World Forum for Harmonization of Vehicle Regulations

Sixty-second session
Geneva, 7–10 June 2011
Item 4(b) of the provisional agenda
Heavy duty vehicles – Worldwide harmonized Heavy
Duty On-Board Diagnostic systems

Proposal for Amendment 1 to global technical regulation No. 5

Submitted by the expert from the European Commission *

Figure 4, amend to read:

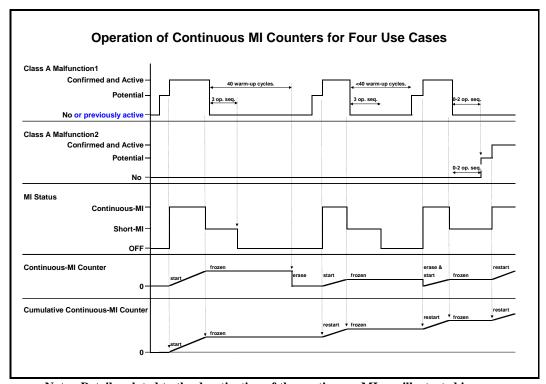
<u>Note</u>: Details related to the deactivation of the continuous MI are illustrated in figure 4bis below in the specific case where a potential state is present."

(b) The continuous MI is deactivated as soon as the monitor has concluded the absence of the malfunction. On the contrary, the status of the malfunction changes from confirmed and active to previously active at the end of the operating sequence.

Details of this mechanism are illustrated in a new figure 4bis, but figure 4 needs to be modified accordingly.

"Figure 4bis: Illustration of the continuous MI deactivation principle

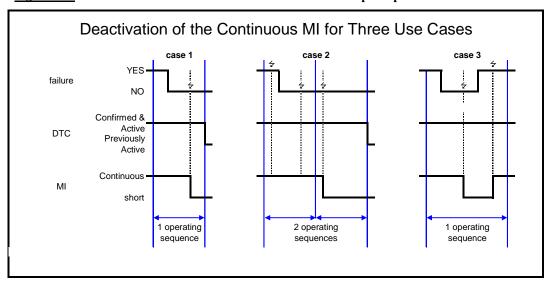
Insert a new figure 4bis, to read:

This new figure aims at illustrating the continuous MI deactivation scheme in 3 typical cases and at reinforcing the consistency between the figures and paragraph 4.6.3.1.4.

means the point where monitoring of the concerned malfunction occurs.

M means the operating sequence when the monitor concludes for the first time that a confirmed and active failure is no longer present.

case 1 means the case where the monitor does not conclude the presence of failure during the operating sequence M.

case 2 means the case where the monitor has previously concluded, during the operating sequence M, the presence of the malfunction.

case3 means the case where the monitor concludes, during the operating sequence M, the presence of the malfunction after having first concluded to its absence."
